Millstone Nuclear Power Station, Unit Nos. 1, 2 and 3
2001 Radioactive Effluent Release Report

2001 Radioactive Effluent Release Report

Change Request #: REMODCM-00-02

Check: <input checked="" type="checkbox"/> REMM <input checked="" type="checkbox"/> ODCM <input checked="" type="checkbox"/> Unit 1 Effluent Controls <input checked="" type="checkbox"/> Unit 2 Effluent Controls <input checked="" type="checkbox"/> Unit 3 Effluent Controls			
Change Request #: REMODCM-01-01 Revision 21

FIGURE 1D-2
SIMPLIFIED AIRBORNE EFFLUENT FLOW DIAGRAM
MILLSTONE UNIT TWO

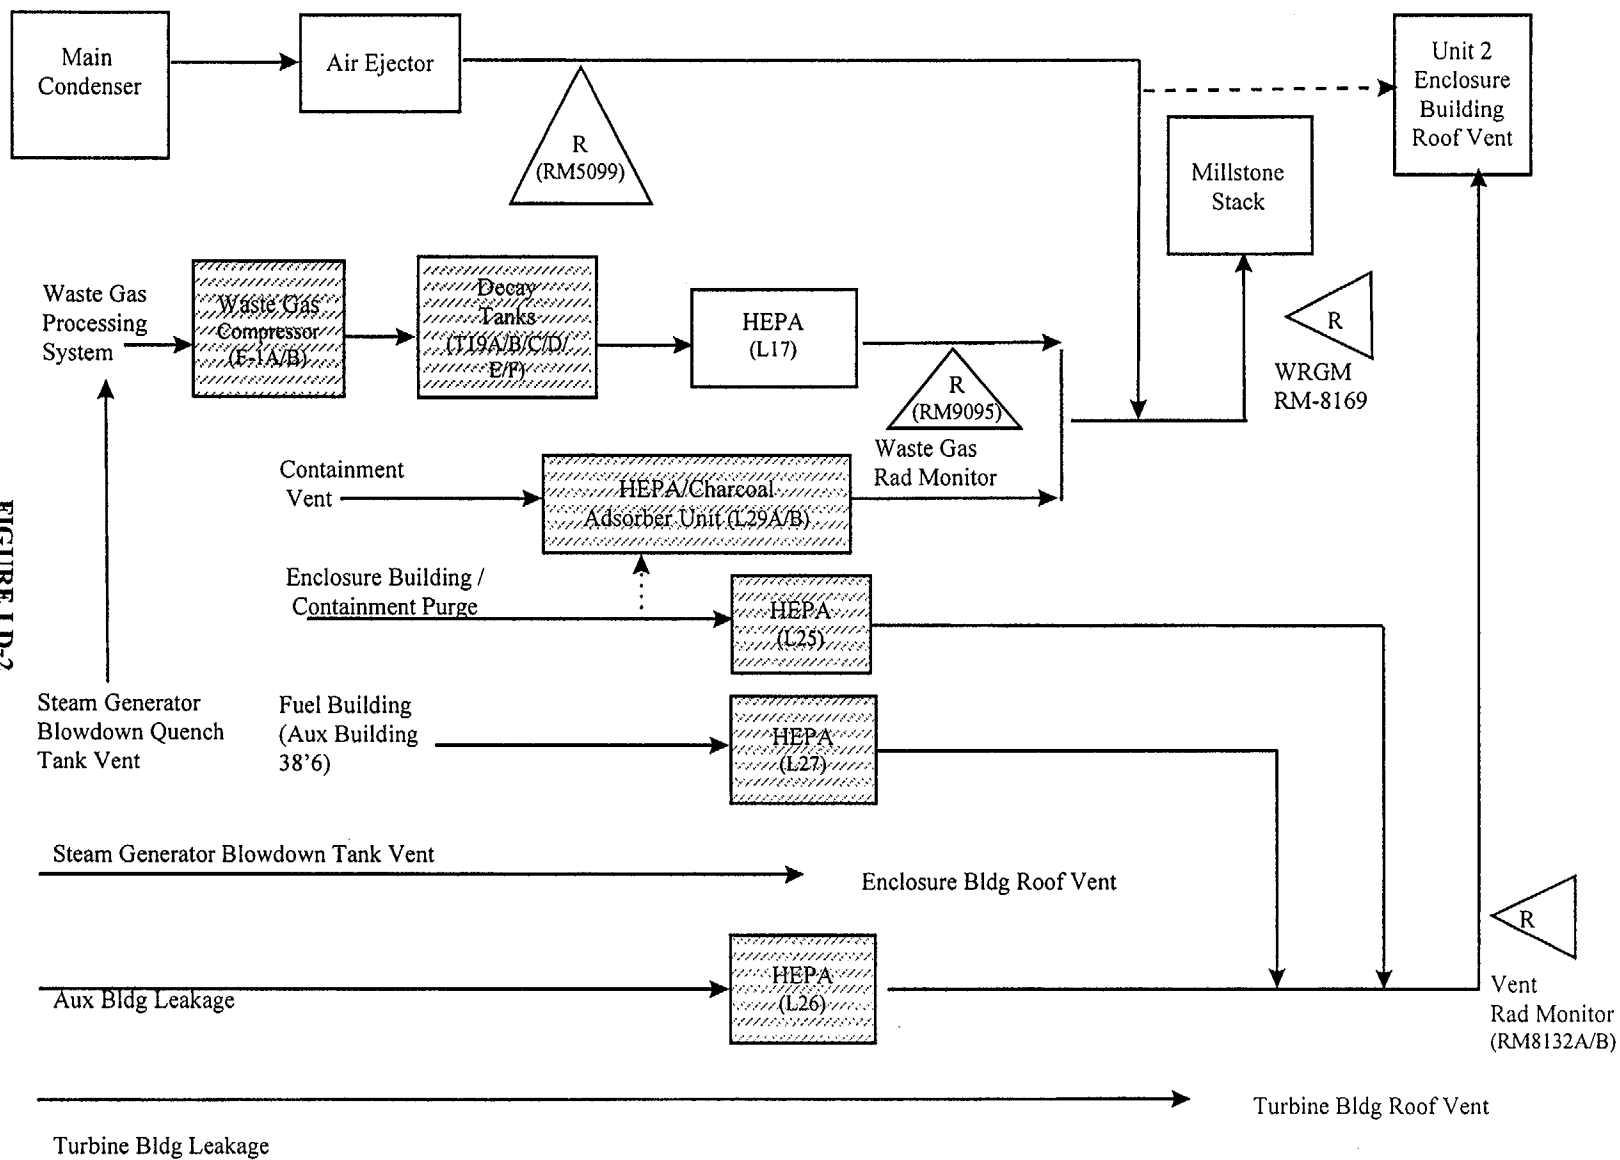
Sect	Section Title	Page	Description of change and reason
Fig. I.D-2	Simplified Airborne Effluent Flow Diagram - U2	I.D-12	<ol style="list-style-type: none"> 1.Change "Unit 1 Stack" to "Millstone Stack" to maintain consistency with designation in design documentation. 2.Changed Stack Rad Monitor (1705-18A/B) to WRGM (RM-8169) because Unit 2 now monitors it's own releases to the Millstone Stack using the WRGM. 3.Corrected flow path for primary release from air ejector to Millstone stack with an alternate release to the Unit 2 vent instead of just a release to the vent.
Fig. I.D-3	Simplified Airborne Effluent Flow Diagram - U3	I.D-13	<ol style="list-style-type: none"> 1.Change "Unit 1 Stack" to "Millstone Stack" to maintain consistency with designation in design documentation. 2.Changed Stack Rad Monitor (1705-18A/B) to SLCRS (HVR-19B because Unit 3 now monitors it's own releases to the Millstone Stack using the SLCRS radiation monitor. 3.Changed containment drawdown/ILRT release to hogger drawdown release to specify which drawdown release is applicable in accordance with Table I.D-3. 4.Added containment vacuum system releases to the Millstone Stack to show an effluent type release not previously diagrammed.

- 4. Corrected Figure I.D-2 (p. I.D-12) to show air ejector release pathway to the Unit One Stack with alternate release pathway to Unit 2 vent.
 - 5. Corrected Figure I.D-3 (p. I.D-13) to show containment vacuum system release pathway to the Unit One Stack and to specify drawdown as the hogger drawdown.

FIGURE I.D-3
SIMPLIFIED AIRBORNE EFFLUENT FLOW DIAGRAM
MILLSTONE UNIT THREE
I.D-13

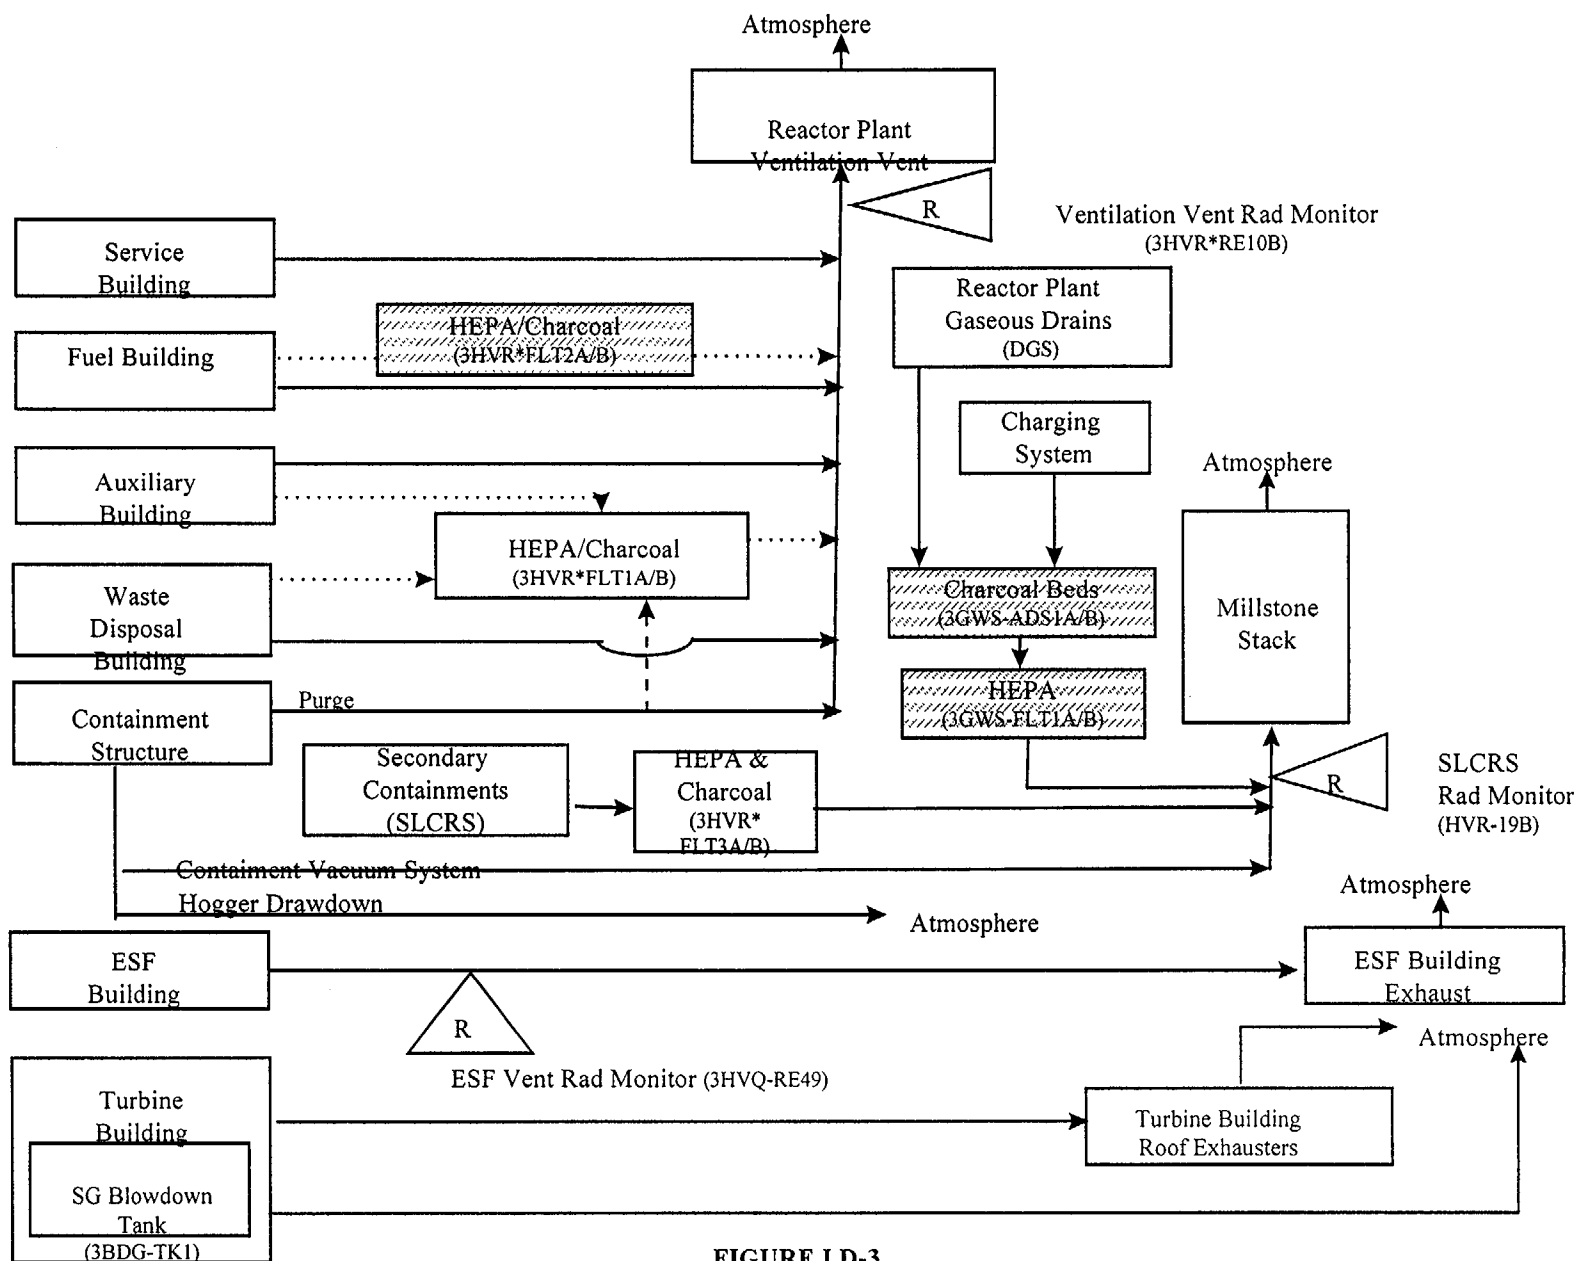
- Millstone Stack sampling requirements in Table I.D-3 (p. I.D-7)
 - Replace Stack Rad Monitor with SLCRS Rad Monitor in Diagram I.D-3 (p. I.D-13).
 - Noble gas setpoint requirements in Section II.F.4 (p. II.F-2).
